Lot 194 - Ballard Road  
1931 Ballard Road  
Fuquay-Varina, NC 27526

# The Selma - LH

29-Apr-2025 - Redlines - DD

5.22.25 Design upgrades - CW

CRAWL SPACE FOUNDATION 'ENGLISH COUNTRY'  
SCALE: 1/8"=1'-0" ON 11x17, 1/4"=1'-0" ON 22x34

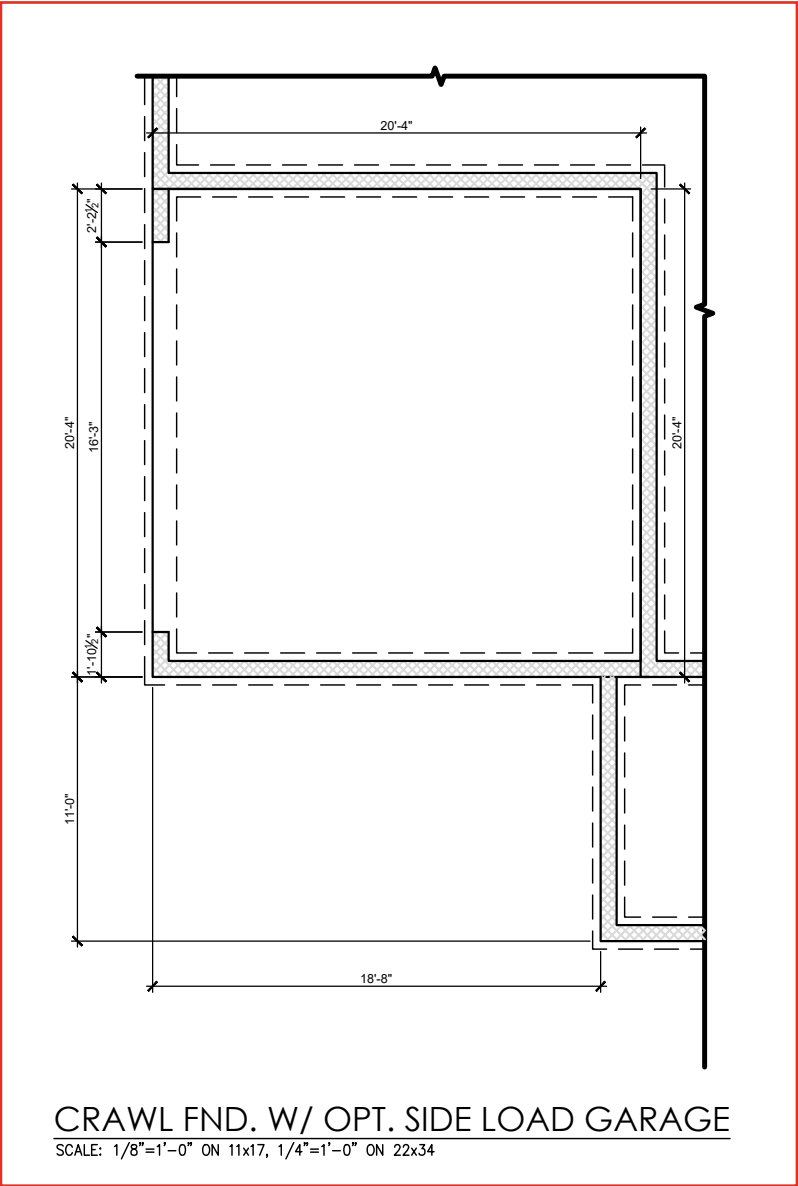
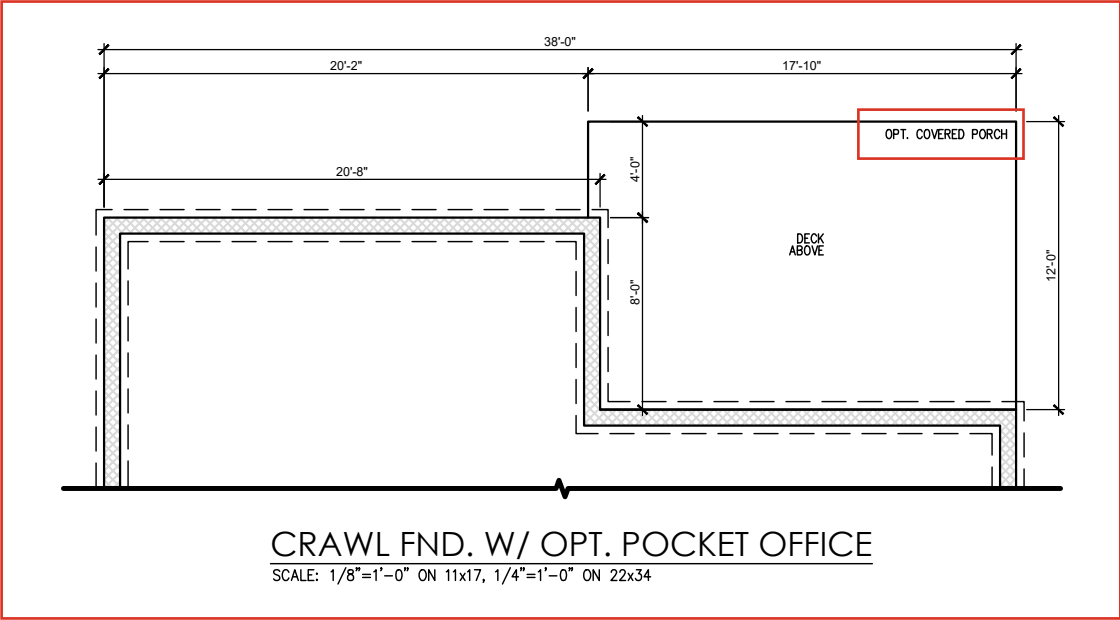
Pocket Office -  
1.2.1c

Side Load Garage  
- 1.2.1c

FIRST FLOOR PLAN 'ENGLISH COUNTRY'  
SCALE: 1/8"=1'-0" ON 11x17, 1/4"=1'-0" ON 22x34

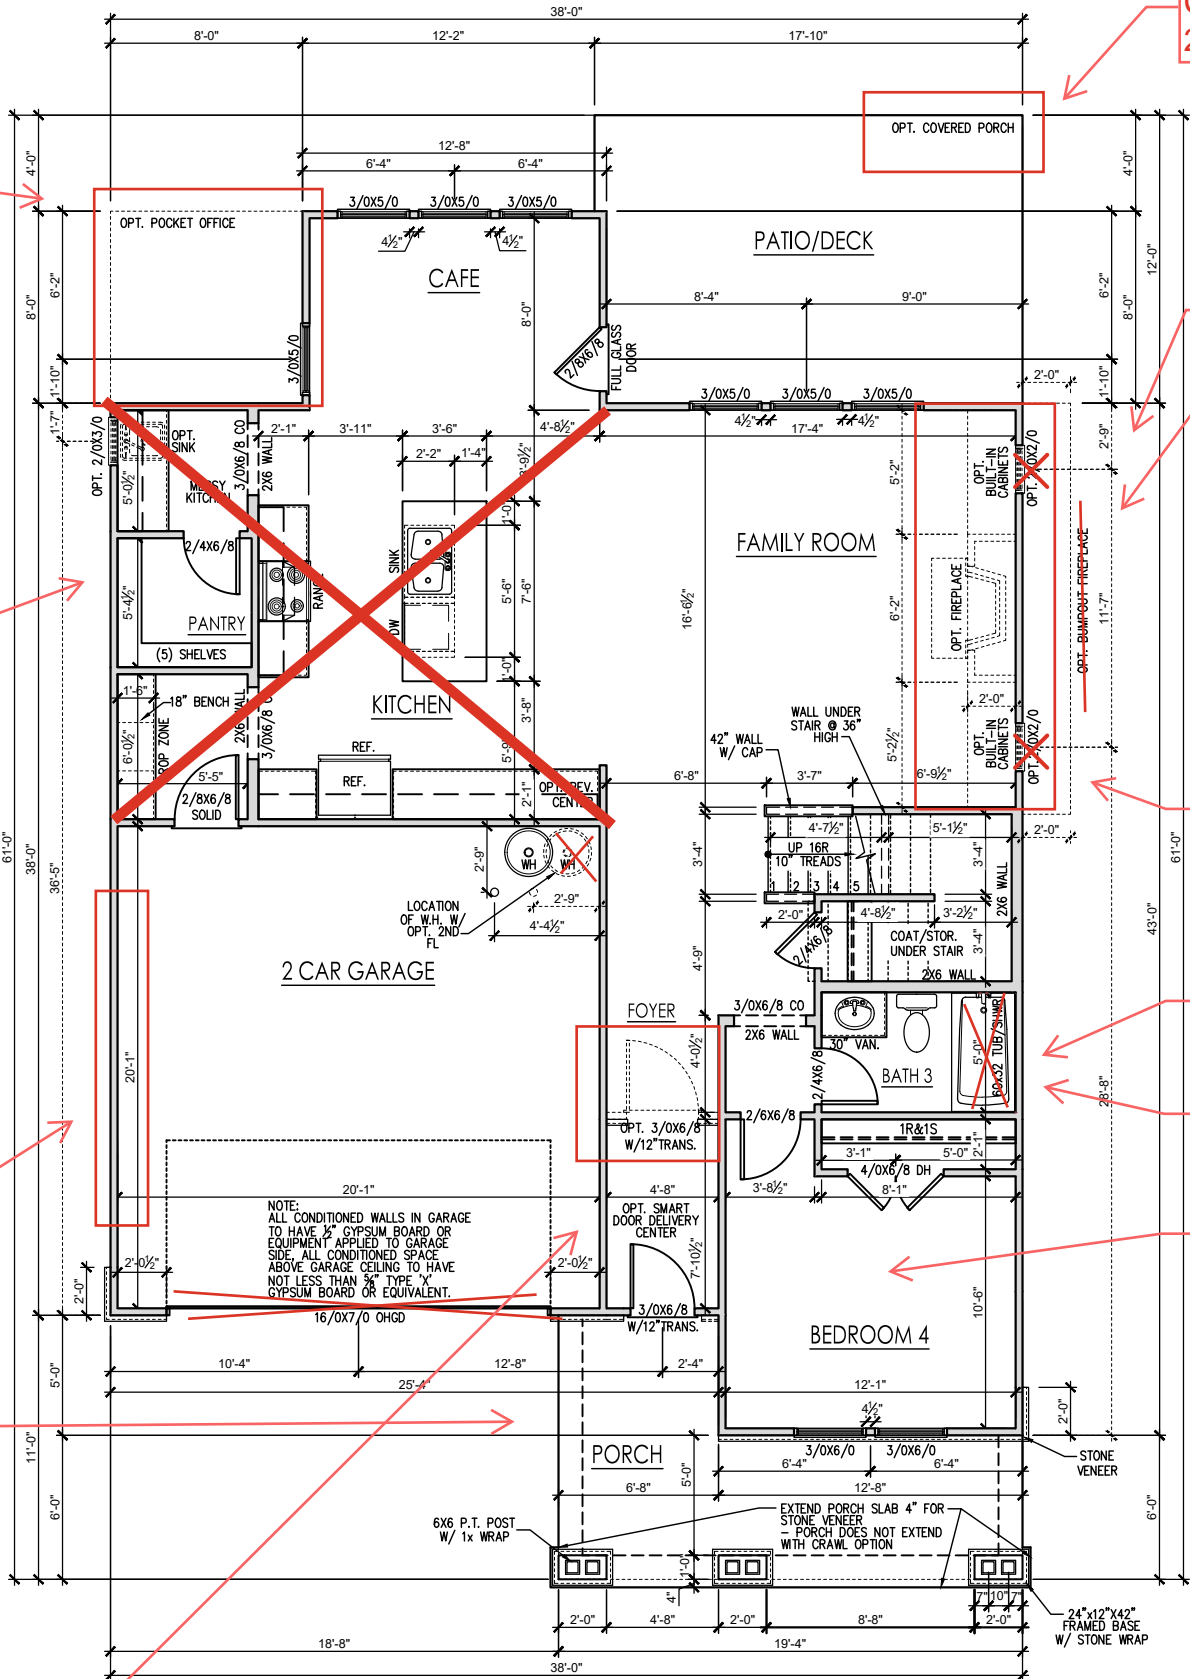
Pocket Office - 2.1.1c

Gourmet Kitchen - 2.1.1c

Side Load Garage - 2.1.1c

Hose bib in corner

Smart Door Delivery - 2.1.1c

Covered Porch - 2.4.1c

Hose bib on corner of home

Floor to ceiling built-ins

Interior Fireplace - 2.1.1c

Shower ILO Tub/ Shower

tile shower pan ilo of fiberglass

LVP ilo carpet

OPT. GOURMET KITCHEN  
SCALE: 1/8"=1'-0" ON 11x17, 1/4"=1'-0" ON 22x34

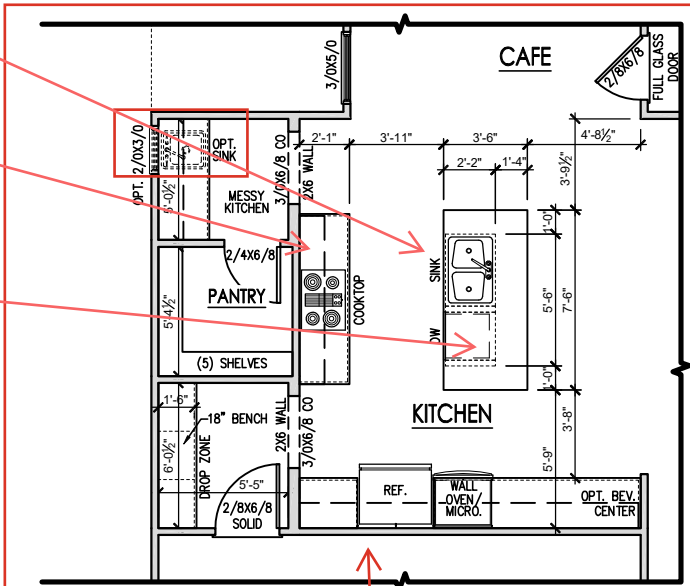
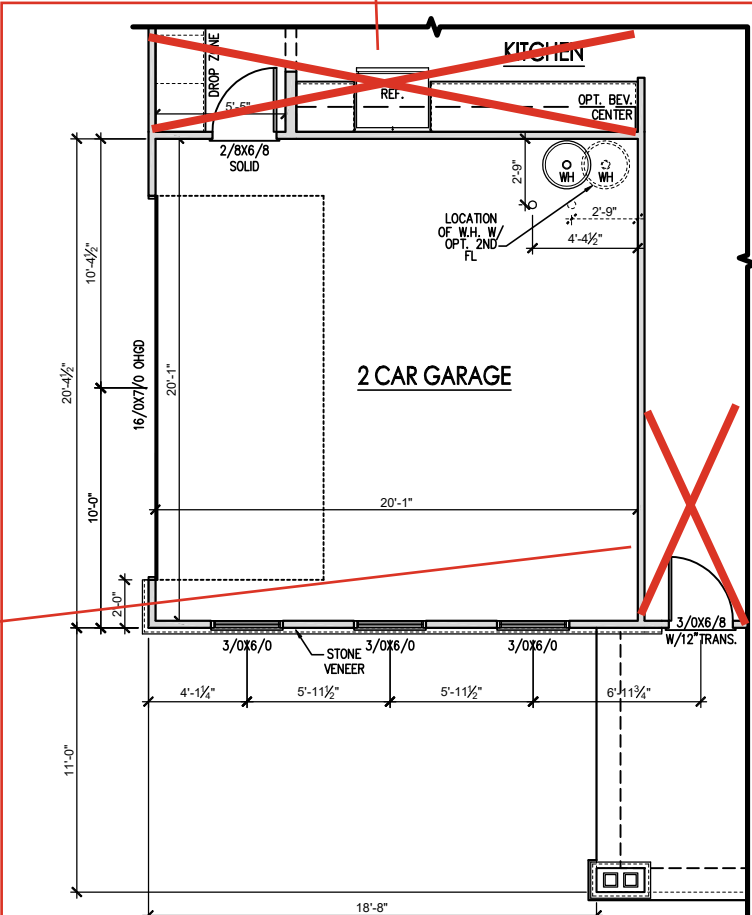
Floor to Ceiling  
Built-ins

install SS  
farmhouse sink

under cabinet  
lighting

Remove  
countertop  
overhangs/add  
cabinet for trash  
pull out

PLAN 4 - THE SELMA - LH  
SINGLE FAMILY  
Second Floor Plan Options

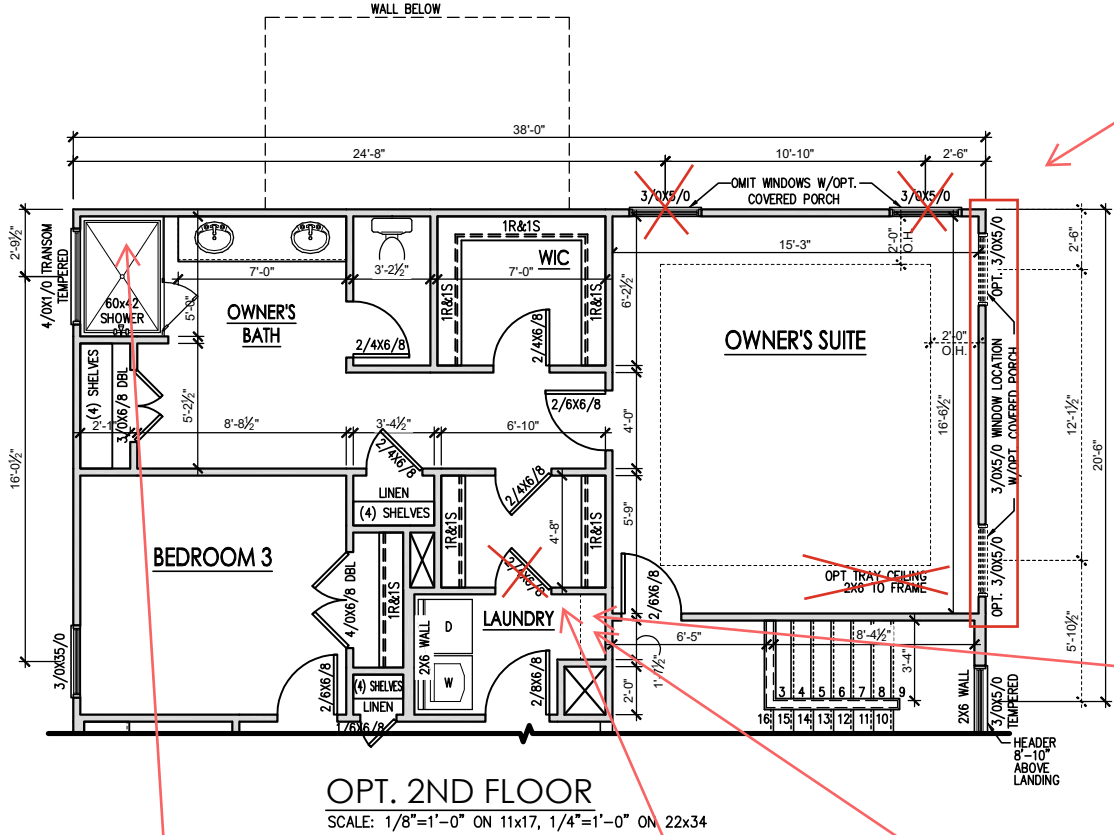
Windows Move  
Due to Covered  
Porch

Wooden shelf ilo  
wire

Opt. Pocket Door

Laundry Sink

tile shower floor ilo  
of fiberglass pan

PLAN 4 - THE SELMA - LH  
SINGLE FAMILY  
Front & Rear Elevations (Crawl or Stem  
Wall) 'English Country'

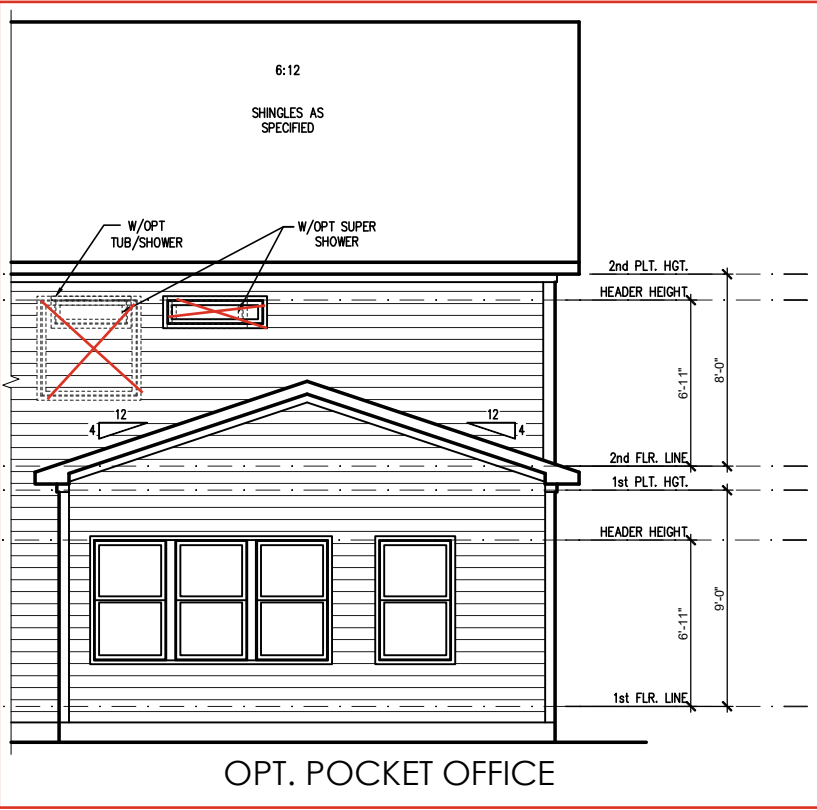
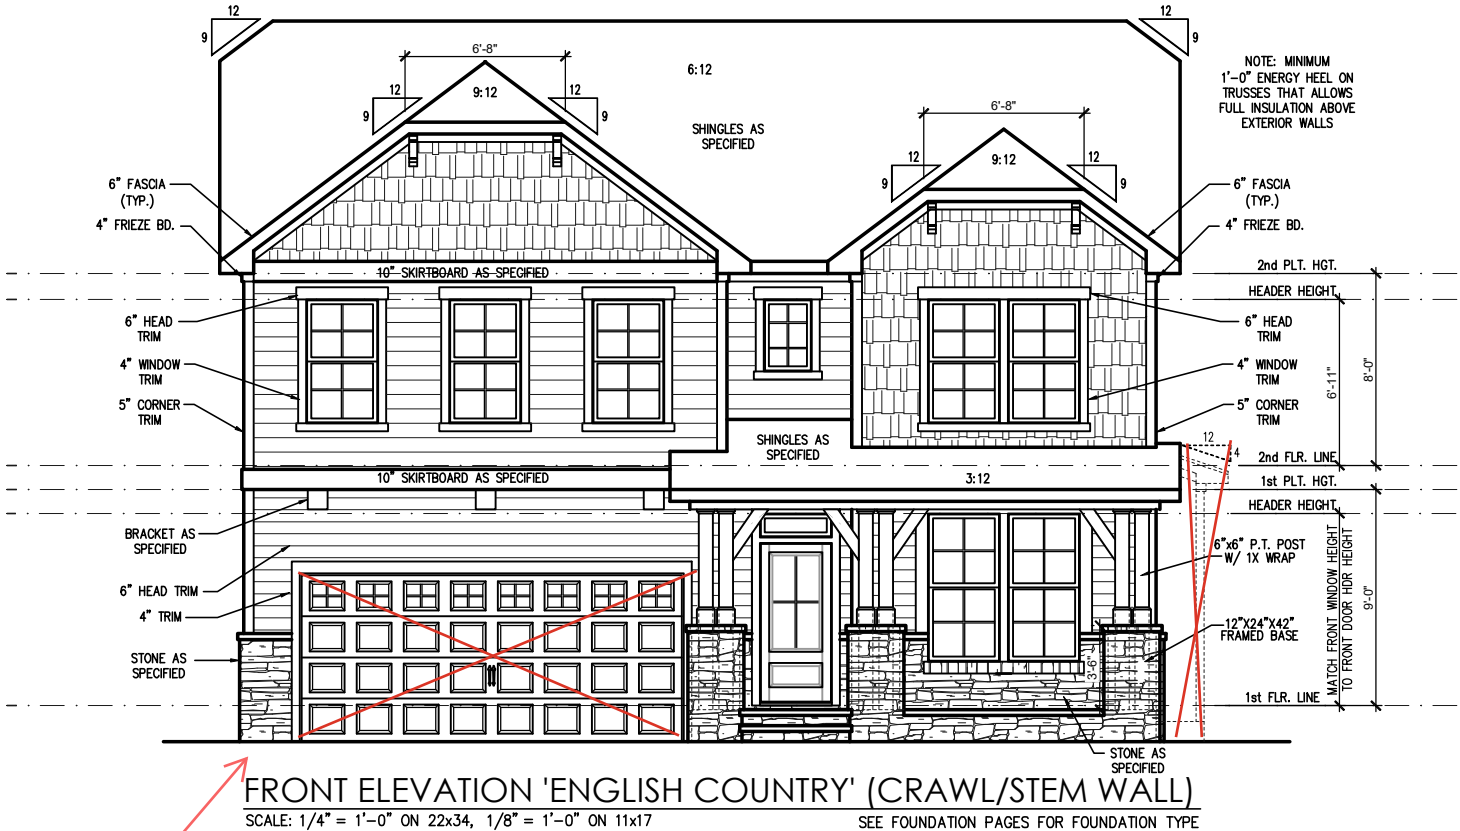
Side Load Garage  
- 2.5.1c

LEFT SIDE ELEVATION 'ENGLISH COUNTRY' (CRAWL/STEM WALL)

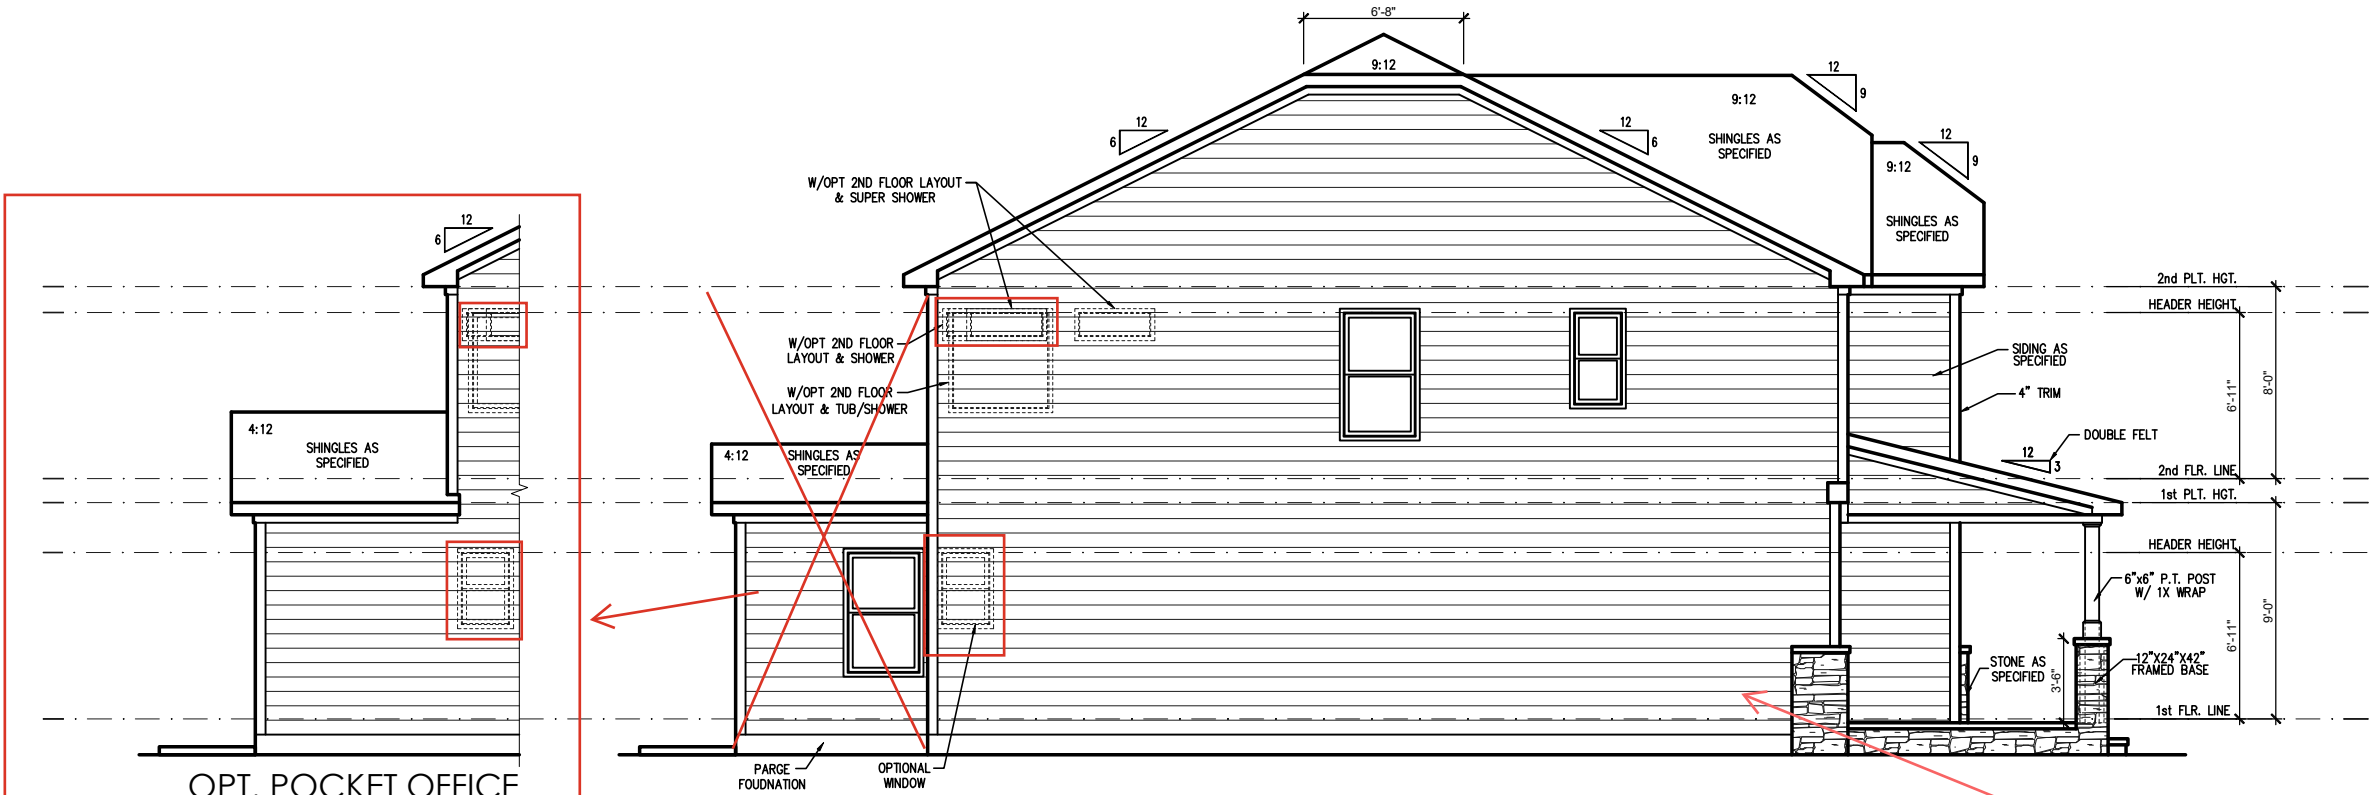
Covered Porch - 2.4.1c
